NOTE	
Subject:	EPA Comments on MidAmerican Energy Co, Riverside Generating Station, Bettendorf, IA Round 7 Draft Assessment Report
To: From:	File Jana Englander, OSWER, US EPA

Date: January 28, 2011

> Re: Comments to Draft Coal Combustion Waste Impoundment Round 7 Dam Assessment Reports for Neal North Energy Center (Site #13), Walter Scott Energy Center (Site #14), Riverside Generating Station (Site #15), and Louisa Generating Station (Site #16)

Re: Comments to Draft Coal Combustion Waste Impoundment Round 7 Dam Assessment Report for Riverside Generating Station (Site #15)

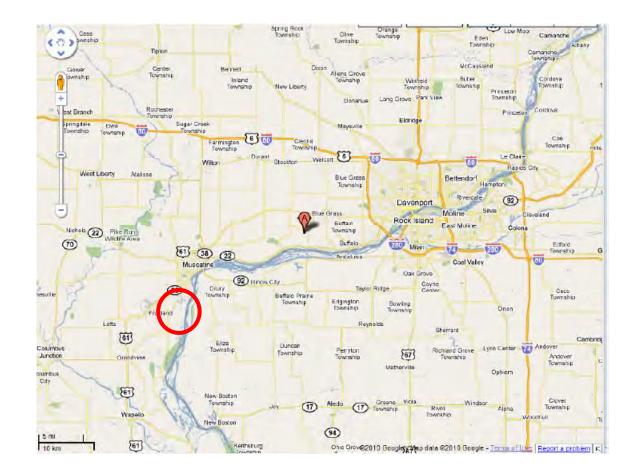
**Section 2.1:** The general description and figures 2.1a and 2.1b relate to IPSCO Steel, not Louisa. The Louisa Generating Station is further southwest near Fruitland, Iowa, as shown in the red circle on the map below.
